Sites: 8400 and 8420 Glendale Ave NE - B20E066

## **Re:** Drainage Ordinance (14-5-2-1) Violations for Erosion and Sediment Control

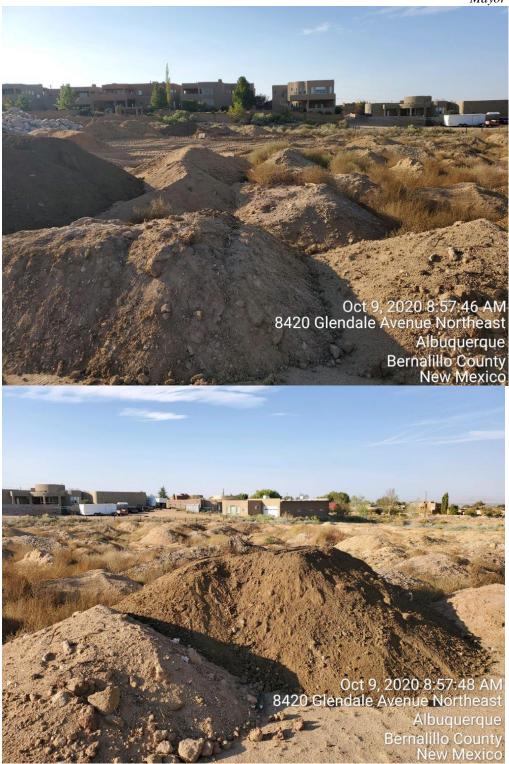
1. Earth disturbance began prior to approval of an NOI and ESC Plan by the City. Loose fill material has also been placed in the floodplain and there are not any Erosion and Sediment Controls in place.

2. The disturbed area and construction activities overlap with construction support activities on the adjacent property at 8500 Glendale, owned by John Jones which also requires NPDES coverage. The SWPPP must identify the areas of control by each Operator.

- 1. The Erosion and Sediment Control Plan (ESC Plan) must be submitted to the City for approval.
- 2. The property owner's NOI and related documentation must be submitted and approved by the City.

- 4. Loose soil in the floodplain must be either compacted or removed as soon as it is exposed and not later than the end of same the day it is exposed.
